EDWIN I. HATCH NUCLEAR PLANT, UNIT NO. 2

AMENDMENT TO FACILITY OPERATING LICENSE

Amendment No. 33
License No. NPF-5

ATTACHMENT TO LICENSE AMENDMENT NO. 33

FUEL TYPE P8DRB265H
MAXIMUM AVERAGE PLANAR LINEAR HEAT GENERATION
RATE (MAPLIHR) VERSUS AVERAGE PLANAR EXPOSURE
FIGURE 3.2.1-7

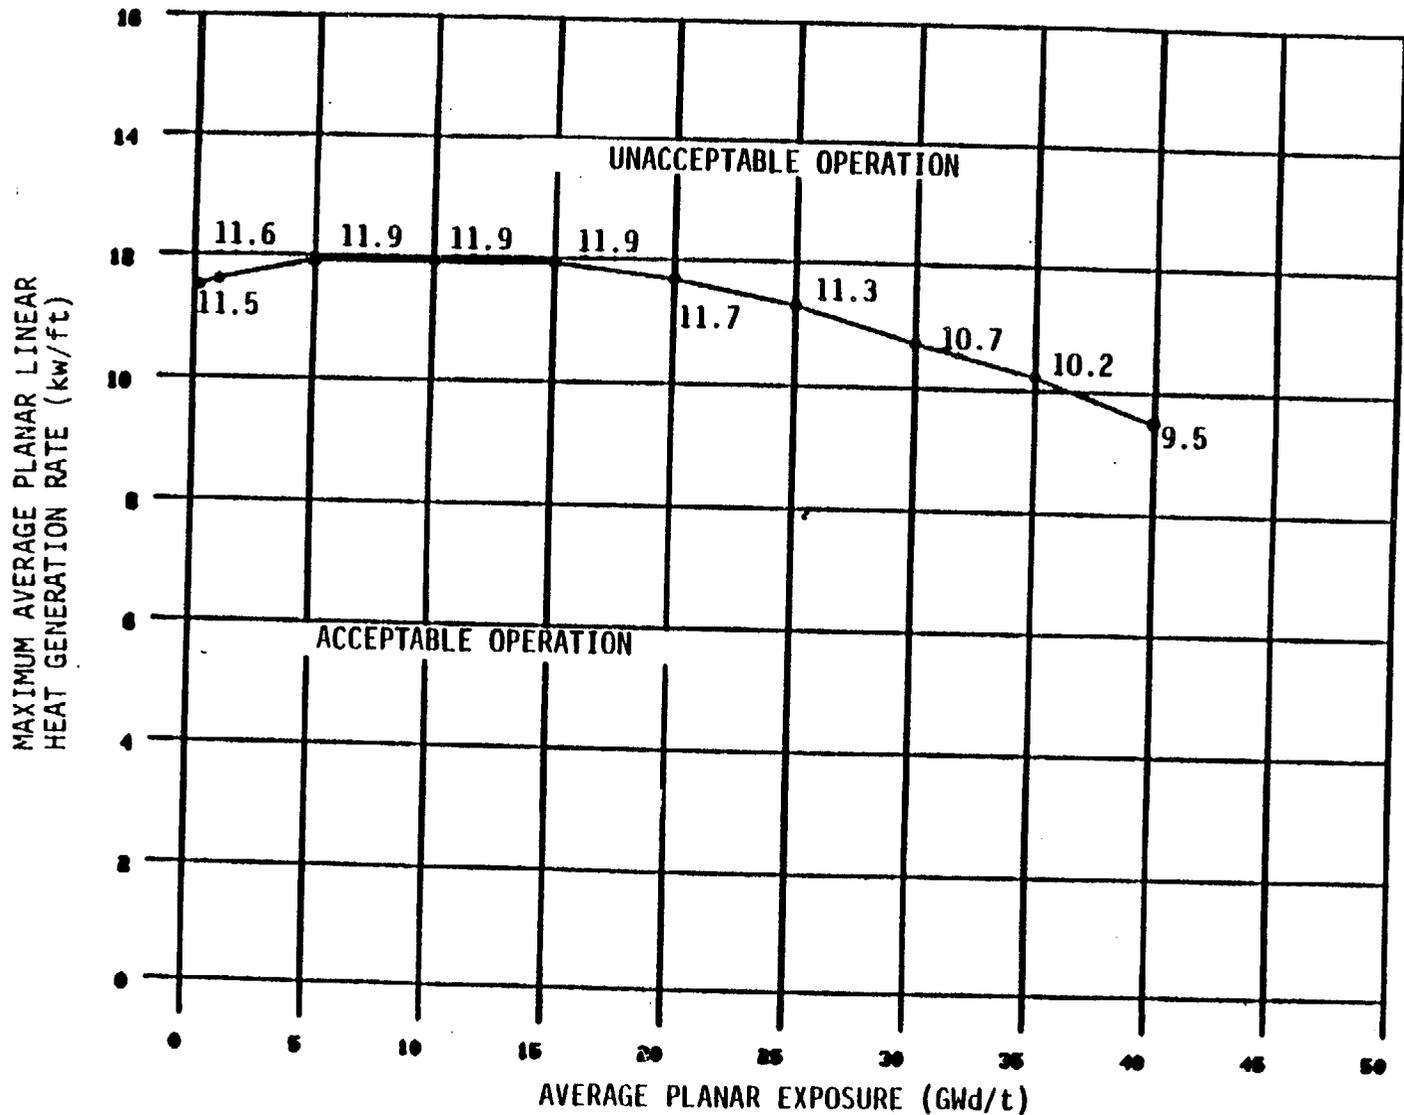
The licensee's submittal provided both new and revised MAPLHGR limits. The new MAPLHGR limits are for the fresh fuel (P8X8R).

The revised MAPLHGR limits for all fuel types have been extended to accommodate exposures to as much as 45 GWd/ST. These limits were generated by methods previously approved (Ref. 14). Although the methodology used is generically applicable for the MAPLHGR limit determination, we believe that the effects of enhanced fission gas release in high-burnup (i.e., greater than 20 GWd/MTU) were not adequately considered in the fuel performance model. In response to this concern, GE requested (Refs. 15 and 16) that credit for approved, but unapplied, ECCS evaluation model changes and calculated peak cladding temperature margin be used to avoid MAPLHGR penalties at higher burnups. This proposal was found acceptable (Ref. 17) provided that certain plant-specific conditions were met. The licensee has stated (Ref. 7) that the GE proposal is applicable to the Hatch Unit 2 analysis with the exception of three exposure points where the calculated peak cladding temperatures for Hatch Unit 2 fuel exceed those assumed in the GE analysis. In those three cases, the peak cladding temperature for the Hatch Unit 2 fuel is less than 20°F larger than the limiting temperature in the generic analysis. The licensee has also stated that a temperature change of less than 20°F (per 10CFR50, Appendix K, Section II.1.b) is not considered significant. We accept this conclusion and conclude that the MAPLHGR Limits proposed for Cycle 4 operation of Hatch Unit 2 are acceptable.
